*Kane County Division of Transportation
Longmeadow Parkway Section C1 – Contract 63955*

Addendum #2 – September 27, 2018

Addendum #2, as issued by the Kane County Division of Transportation on September 27, 2018, includes the following revisions and clarifications:

**WALL 1 - RAILING DETAILS
STRUCTURE NO. 045-3024**

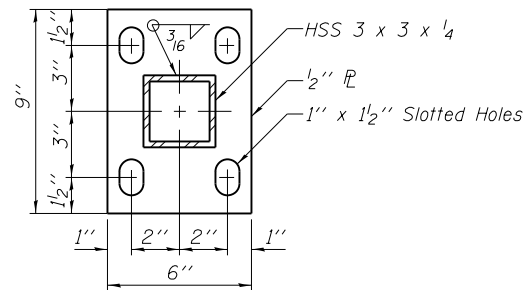
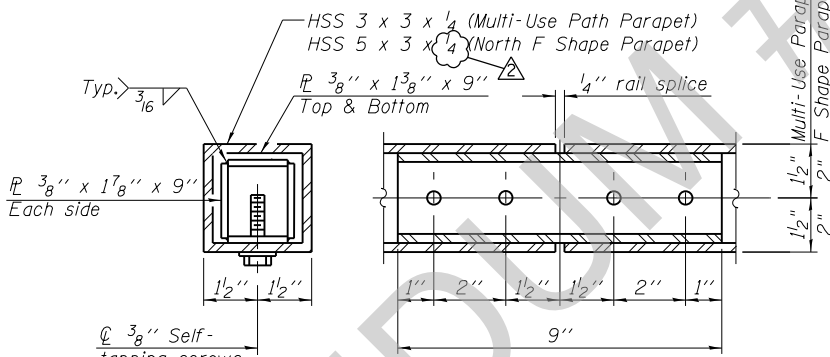
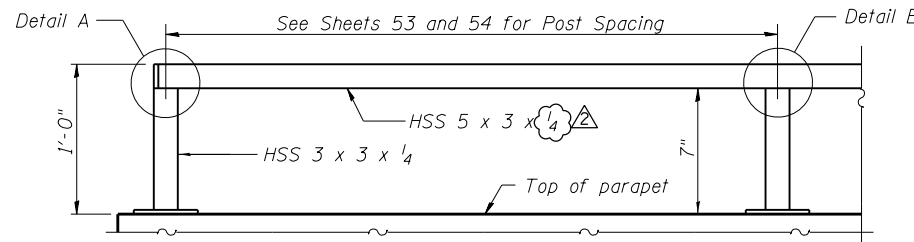
- Sheets 116, 154, & 171 - Revised the parapet railing on the F Shape Parapet from HSS 5 x 3 x ½ to HSS 5 x 3 x ¼. Also, revised the Parapet Railing Elevation at Expansion Joint Detail to indicate the appropriate detail that is to be referenced at various locations along the railing.
